**STATEMENT OF RESPONSE TO  
AN BORD PLEANALA OPINION**

**STRATEGIC HOUSING DEVELOPMENT**

**PRIORSLAND  
CHERRYWOOD SDZ  
DUBLIN 18**

**1 CARRICKMINES LAND LTD.**

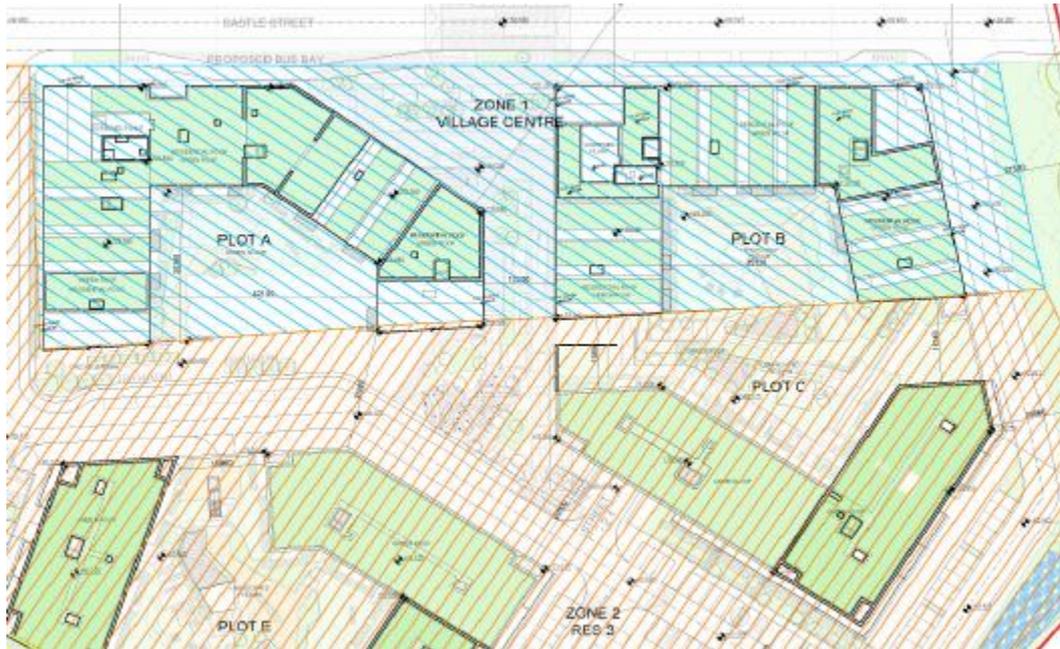
***Overlay of land use map and proposed uses as specified in the SDZ.***

It is noted that at SHD Stage 2 pre-planning consultation in 2020 a query arose as to whether all of the proposed Village Centre uses proposed were fully located within the Village Centre zoning as outlined in Map 6.3 of the Planning Scheme.

A similar issue arose with the previous SDZ Planning Application Ref. DZ21A/0677 where a proposal to locate the community facilities in Block E (within the RES3 zoning) was considered non-compliant by DLRCC.

Please refer to the MOLA Architecture Design Statement and the Response to Item 3 on page 36 of same, which shows the proposed Village Centre Blocks A and B of the current proposal sitting fully within the Village Centre zoning and with Block C (all apartments) within the RES 3 zoning. The zoning boundary between the Village Centre and RES3 zoning is clearly shown and it is evident that no Village Centre elements are sitting within the RES3 zoning.
